**Proposed Rulemaking for Effluent Limitation Guidelines and New Source Performance
Standards for the Airport Deicing Category
74 Fed. Reg. 44,675 (August 28, 2009)
Docket No. EPA-HQ-OW-2004-0038**

**AFFIDAVIT OF DAVID ISHIHARA
Massachusetts Port Authority**

Figure 3. Cost Per Pound of COD Associated with ADF Removed by the Proposed Rule Versus Annual ADF Usage at Airports Where Additional Controls Are Estimated to be Required to Achieve 20 Percent Collection.

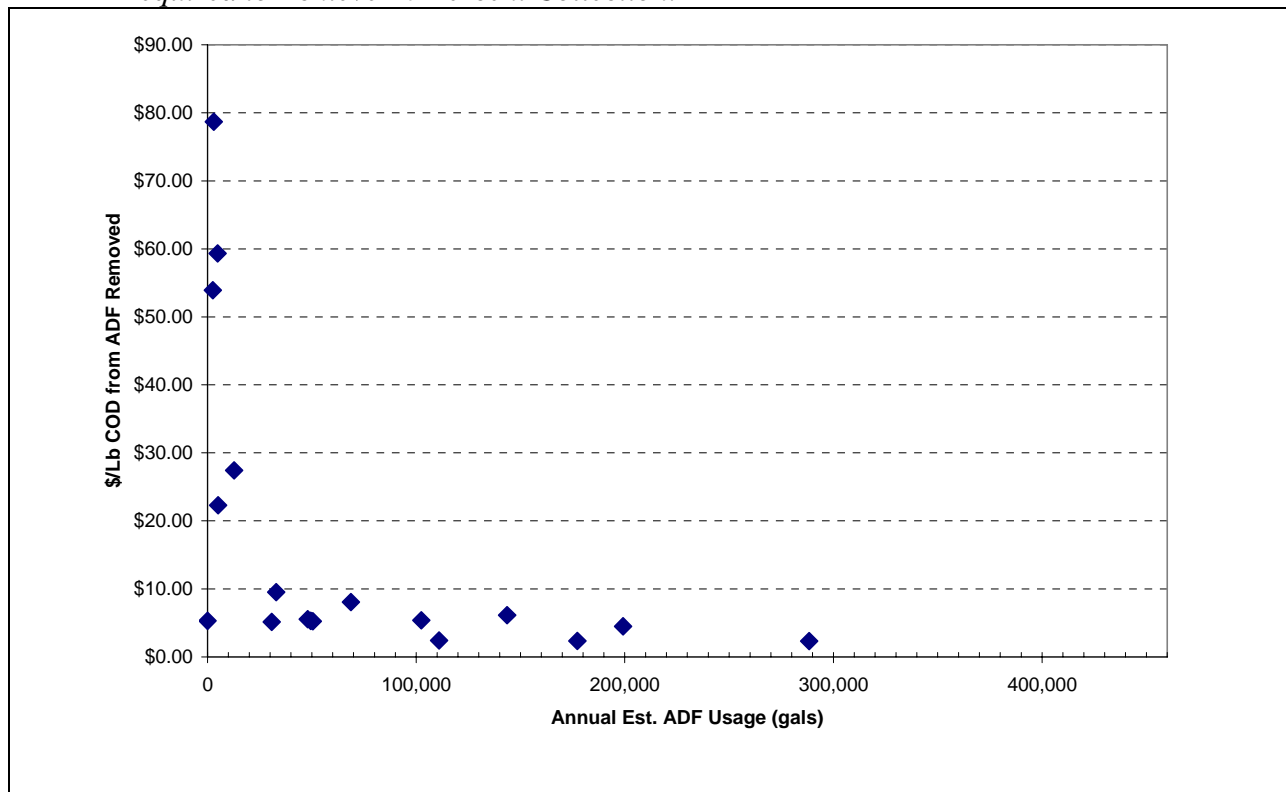
The values presented here are an optimistic portrayal of the cost effectiveness of the proposed rule. All of these analyses are based on EPA's estimates of ADF usage, baseline COD loadings, COD removal, and cost of compliance. As is presented elsewhere in these comments, there is reason to believe that ADF usage, baseline COD loadings to surface waters and pollutant removal have been overestimated and collection and treatment costs have been underestimated. Correcting inaccuracies in EPA's estimates will significantly increase the cost per pound of COD removed by the Proposed Rule.

Figure 5. Planning Level Opinion of Probable Capital Costs for Installation of AFB Systems Per Treatment Rates

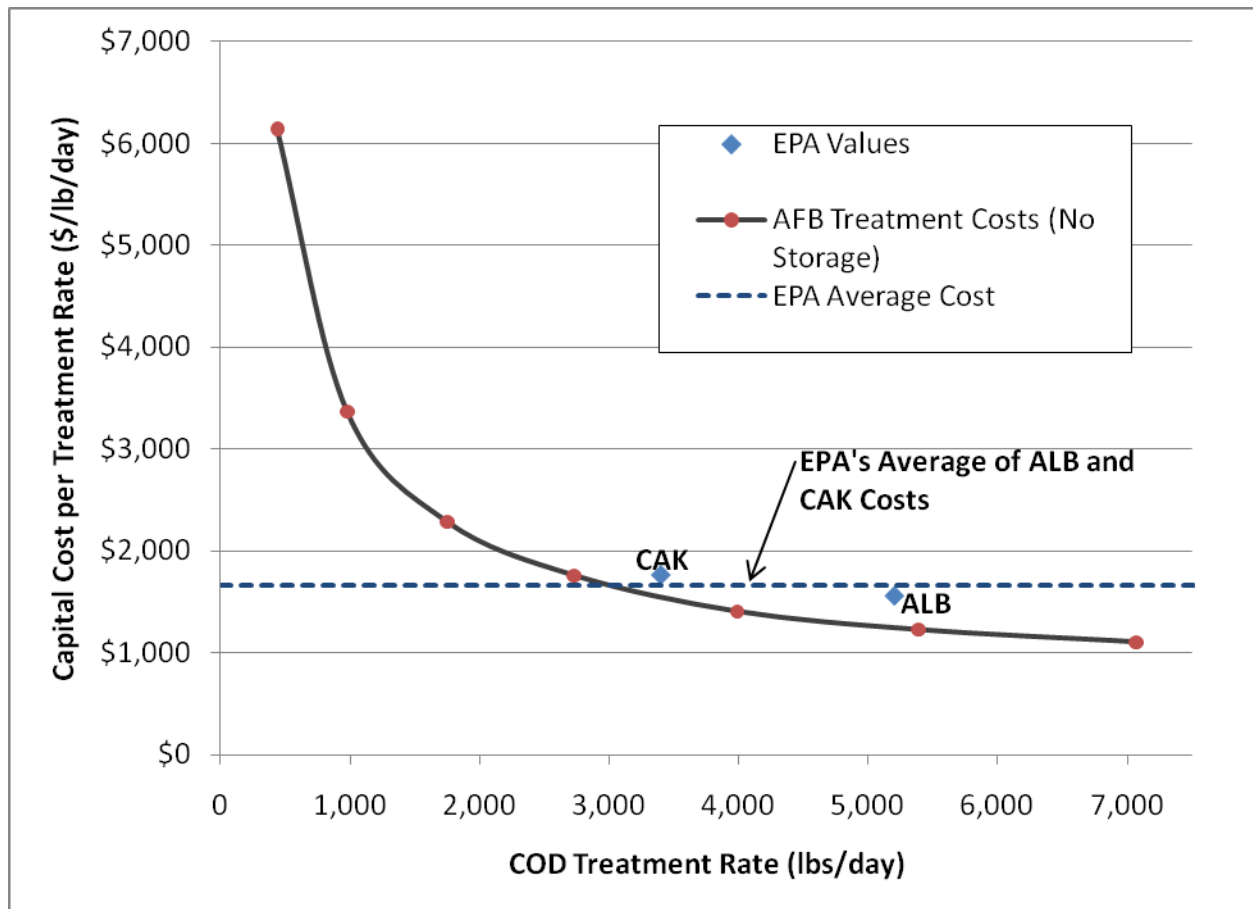
ACI-NA through consultation with industry consultants experienced in AFB design has developed the cost Figure 5 below that shows a more appropriate general relationship between cost and COD load for the Primary Treatment Components associated with treatment systems designed to treat less than 7,000 pounds of COD per day. This graphic was prepared by considering the following and illustrates that EPA significantly underestimated the costs associated with small systems.

- AFB systems with capacities greater than 7,000 lbs COD removed per day are also feasible, but the design would required multiple unit processes (i.e., systems with 4, 6, 8 or more reactors) because of practical issues in constructing and transporting individual reactors larger than 16 feet in diameter.
- The cost per pound of COD removal capacity increases rapidly for smaller load removal systems because a) economy of scale issues with the reactor and separator and b) the cost of the support and building systems is relatively constant, varying minimally with COD load removed.
